Docket No. 272 - Development and Management Plan Inspection

Segment 4b Underground Line

Date: February 27, 2008

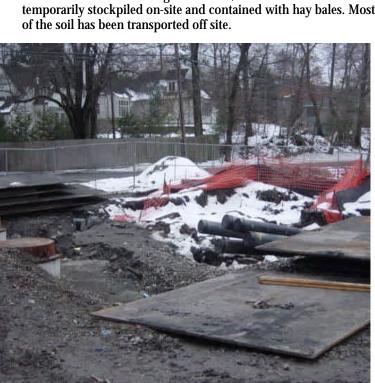
Spills and Material Storage	Spill cleanup materials/kits were observed in the storage yard. 2/27/08	Ensure that spill kits are also present with each vehicle during active construction. 2/27/08	NA
	A light post and associated concrete footings were being stored at sta. #148. Materials appear to be project related. 10/4/07-2/27/08	Remove or attend to materials when feasible. 10/4/07-2/27/08	Needs attention when feasible
	Buried logs uncovered during excavation for vault #15 near sta. #251 have been ground into mulch. The mulch is temporarily stockpiled in the staging area. A stockpile of soil was also observed in the staging area however, controls were not installed at the base. 2/27/08	Ensure that the stockpiled materials are adequately contained. Remove or attend to materials when feasible. 2/27/08	NA
Additional Observations	A wooden fence has been installed at the bridge	None. 2/27/08	NA

Areas of Inspection	Observation	Recommended Action	Corrected Action
	Structure over Stony Brook near sta. #218. 2/27/08
